Environmental Planning Commission

Project #: 2020-004017

SI-2020-00528

Staff Report

A1 LANDSCAPE PLAN

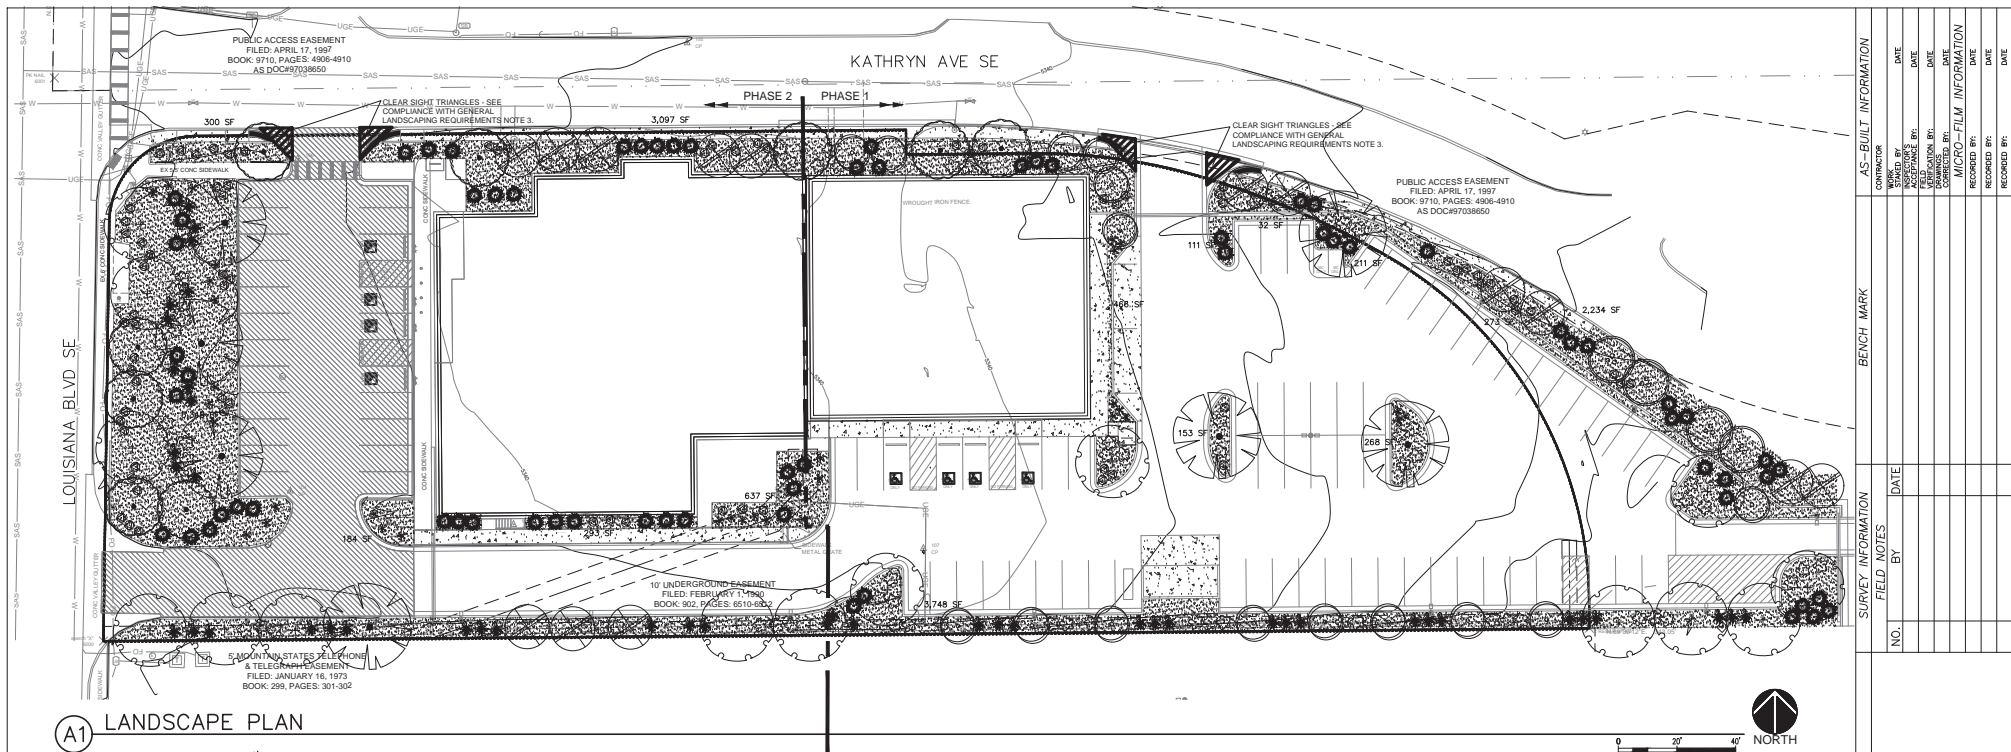
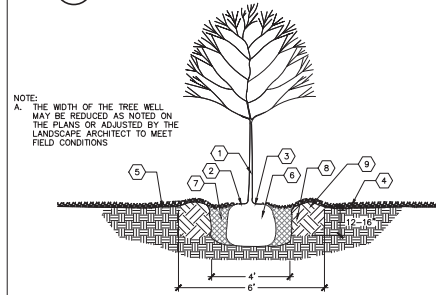
The site plan is generally in compliance with the landscaping requirements pursuant to section 5-6. The minimum surface area of 15% of total lot area minus the building area (.15*67,875) brings the minimum required landscaping of this site to 10,812 sq ft. The applicant is providing close to double at 20,204 sq ft of landscaped area. The plan replaces existing landscaping within the site and provides a visually appealing landscape. There are also street trees in accordance to section 5-6(D), the street trees average a spacing of 25' on center.

As per section 5-6(C)(13)(b), surface runoff within NR-SU zone districts shall be directed into depressed water collection areas that are located in landscaped areas and that meet all applicable standards in the DPM. The landscape drawing demonstrates that the western most portion of the landscaped area shall be used for surface runoff collection, however, no notches are shown on the landscape plan nor the grading and drainage plan.

The landscaping in the southern portion of the lot may be problematic as there are trees and plants shown to be installed very close to underground and overhead utility easements. The applicant is to ensure that the landscaping in areas next to easements are installed pursuant to section 5-6(C)(10).

- F. Both the landscape plan and the grading and drainage plan shall clearly show notches in curbing and details per 5-6(C)(13) and as acceptable to the City Hydrologist.

- M. The site plan shall demonstrate that the landscaping in areas next to easements are installed pursuant to section 5-6(C)(10).
 - N. The site plan shall provide missing detail drawings (wall detail, curb cut detail, lighting detail) as needed.

- b. There is a requirement for all electric utility poles to be shown on the site plan. None are shown.
 - c. Landscaping choice of trees along the south side of the property adjacent to the distribution line need to be reviewed for electrical interference with the electric distribution line creating clearance issues. Mature growth width may interfere with conductors.
